# *Final Groundwater Monitoring Report*

## **Former Port Heiden Radio Relay Station Port Heiden, Alaska**

*Prepared for*  
611th Civil Engineer Squadron

*March 2012*

FIGURE 3  
Former Port Heiden RRS Groundwater Monitoring Sample Results

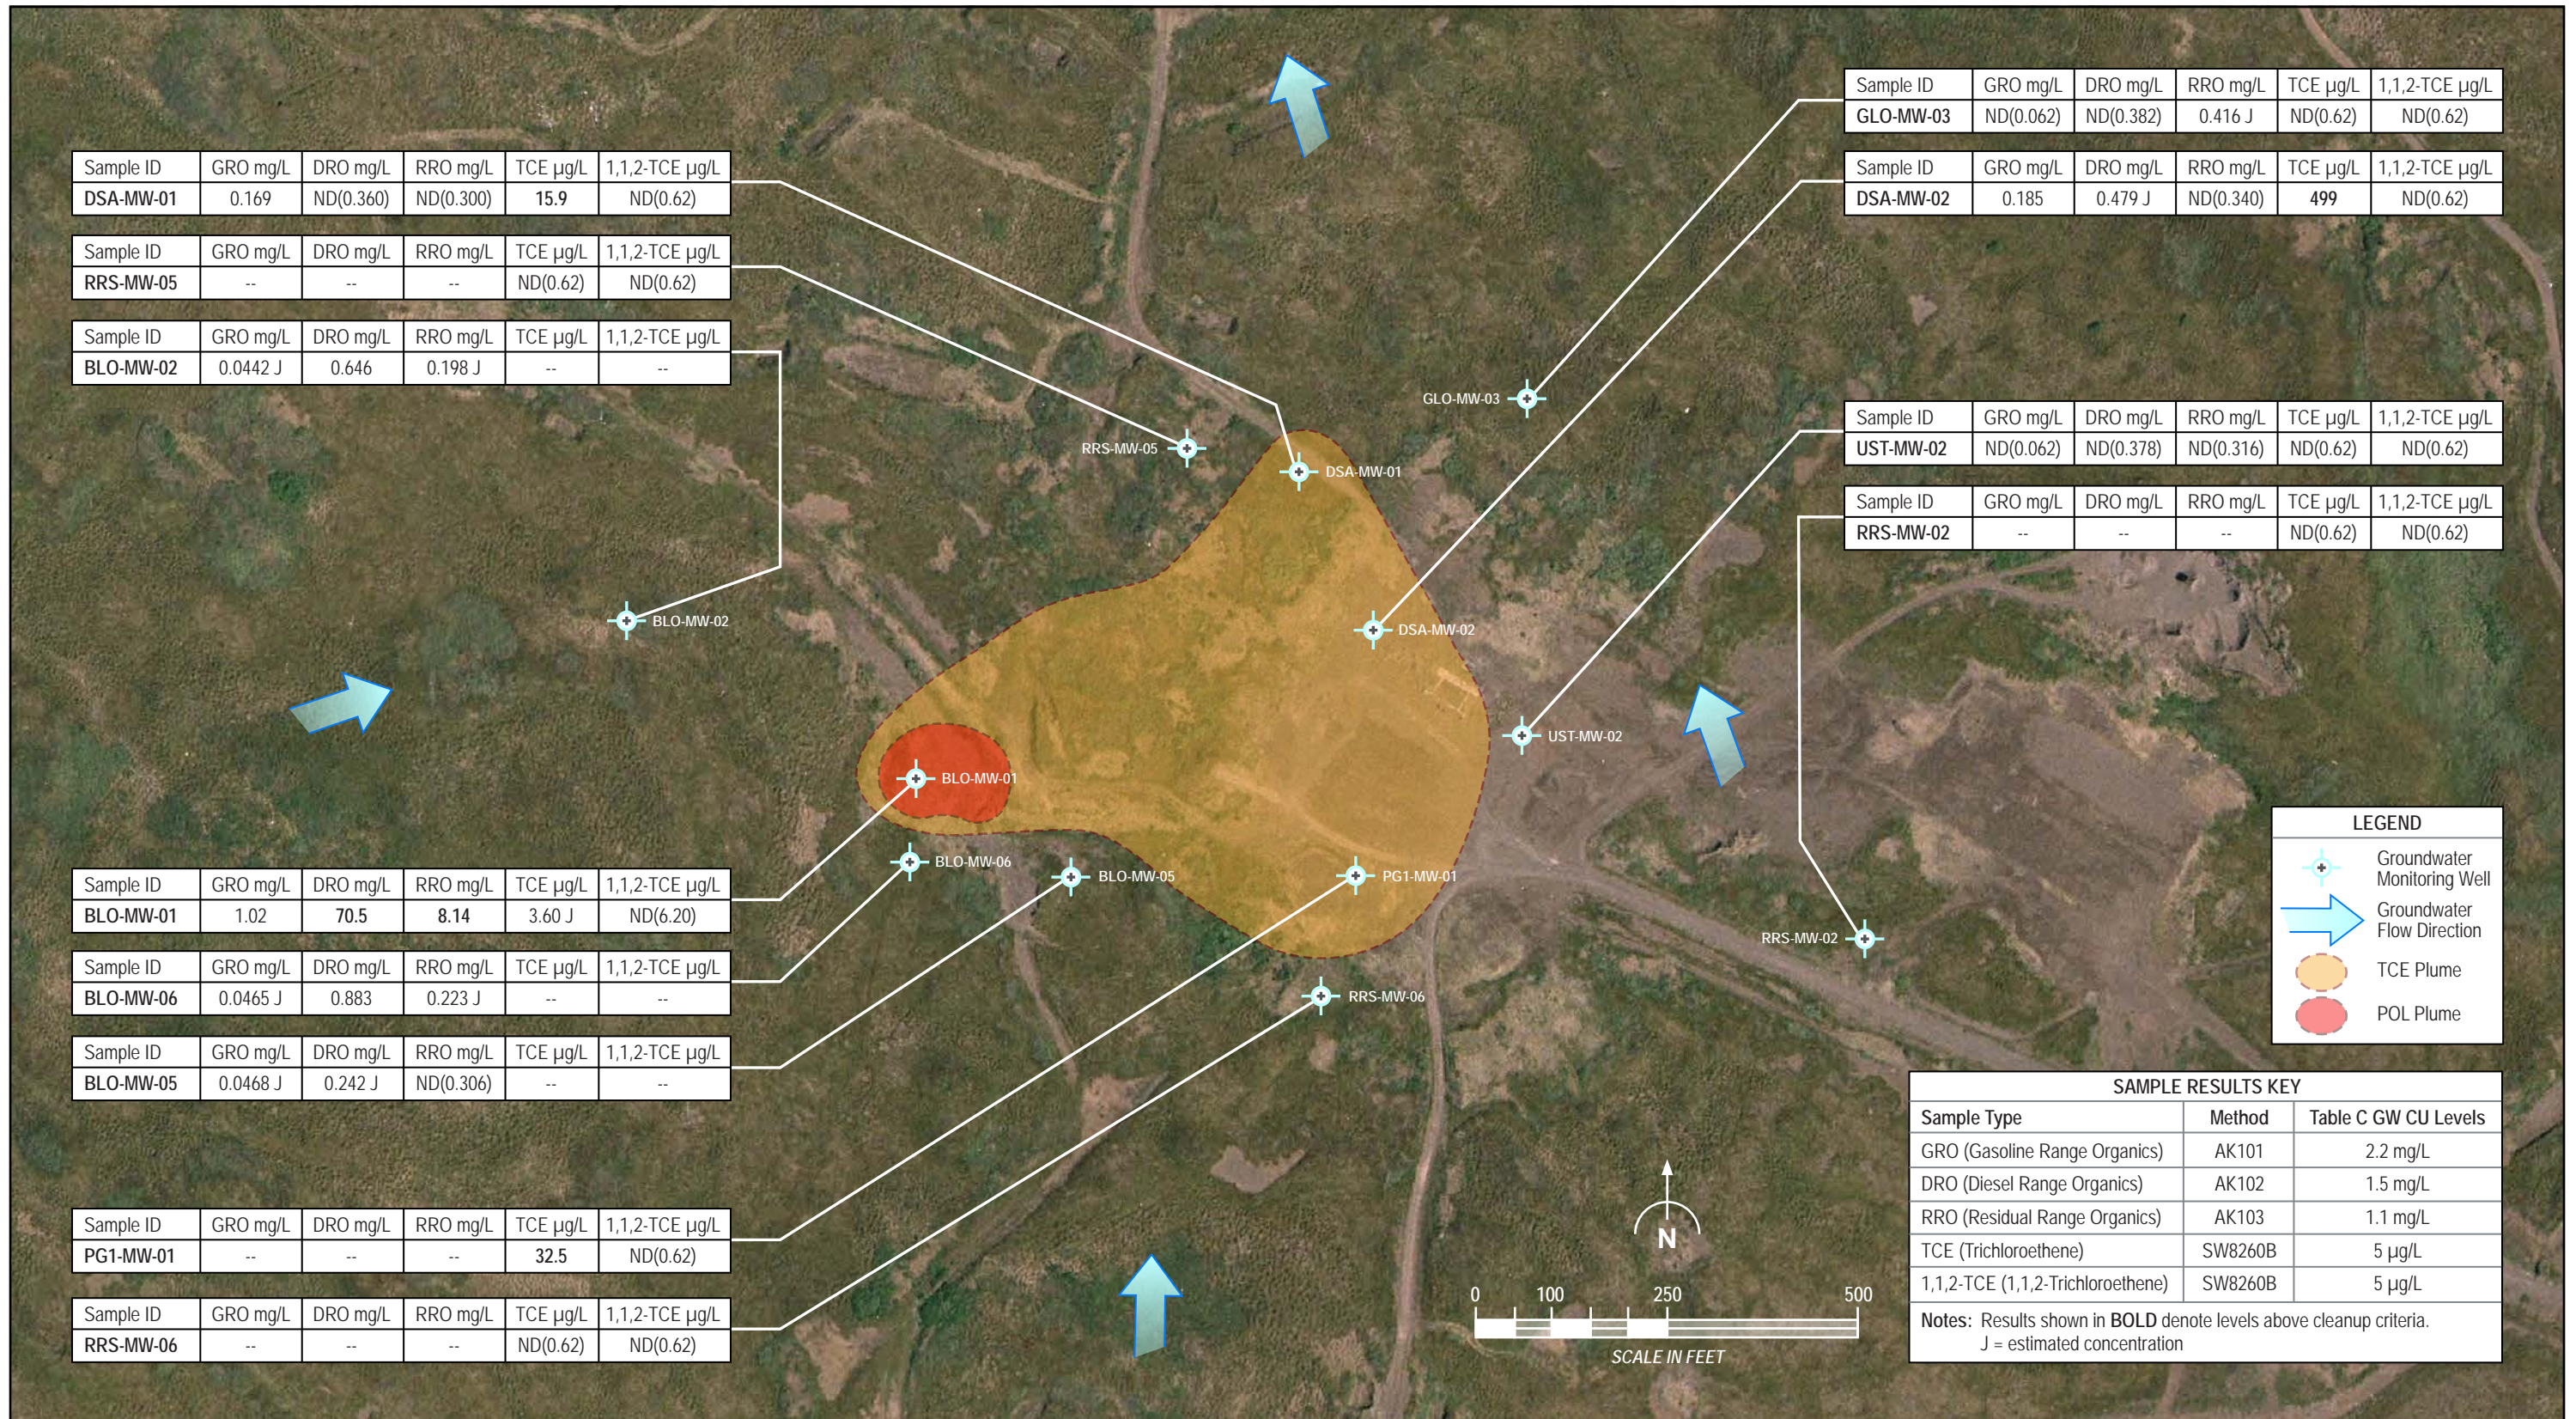
6.		Figure 3	<p>Please ensure that all duplicate sample results that are higher than the primary result are reported (e.g. NVPH11-DSA-MW01-01D). ADEC Technical Memorandum 08-001 “Guidelines for Data Reporting, Data Reduction, and Treatment of Non-Detect Values” (August 12, 2008).</p> <p>Data Reporting  2. Data reduction from field duplicate samples  ADEC regulates based on the maximum result or statistically valid 95% upper confidence limit (UCL) per 18 AAC 75.380(c)(1). <i>Therefore, ADEC requires that the most conservative detectable sample result of the primary and duplicate results be used for management decision making purposes.</i> Primary and duplicate results shall not be averaged.</p> <p>If the primary and duplicate results are both reported as non-detect (ND), the minimum detection limit (DL) should be presented with the data qualification flag denoting the result as ND (U-qualified).</p> <p>If one of the results is reported as non-detect and the other is a detectable concentration, the detected value should be used.</p>	<p><i>This comment is noted and the appropriate groundwater concentrations will be used.</i></p>
